Docket Item #5
BAR CASE #2005-0288

BAR Meeting
May 3, 2006

ISSUE: Concept of four condominium buildings

LOCATION: 900 N. Washington St

Figure 1 Proposed site plan

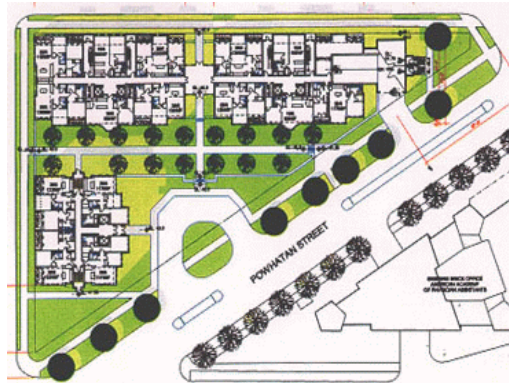
The proposal has been considerably revised since the last hearing attempting to address comments by the BAR, staff, the National Park Service, and public. The changes to the plan and massing have resulted in numerous positive elements that include:

- Reduced overall buildings heights.
- Elimination of the parking garage entrance visible from Washington Street.
- Additional ground level open space.
- A full building break on Montgomery Street.
- A building break on Columbus Street.
- A mid-block pedestrian connection.

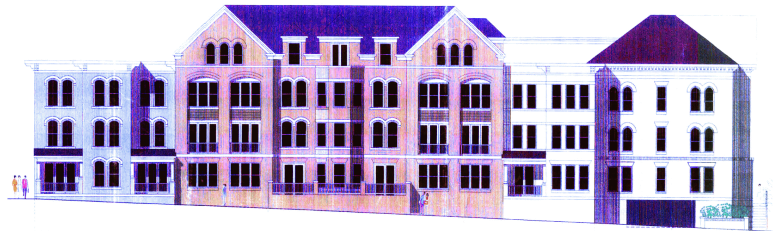
Issue # 1: *Explore options to minimize visibility or relocate the Montgomery Street parking garage entrance.*

Applicant Response: The applicant has relocated the entrance to the parking garage from Montgomery Street to Powhatan Street. Two attached townhouses are proposed to be constructed over the entrance to screen the opening from Powhatan Street.

Staff Response Staff commends the applicant for this revision and feels the entrance off Powhatan Street is less visible from Washington Street and also enables the building on Washington Street to be lowered in height as discussed in more detail below. The applicant has proposed units to screen the garage entrance and has recessed the entrance on Powhatan, all of which will help to minimize its visibility from Powhatan Street. While staff believes the townhouse elements require some additional refinement, the approach is effective and helps to screen the parking and enables the proposal to relate well to the scale of the adjoining neighborhood.

The response addressed the issue raised.
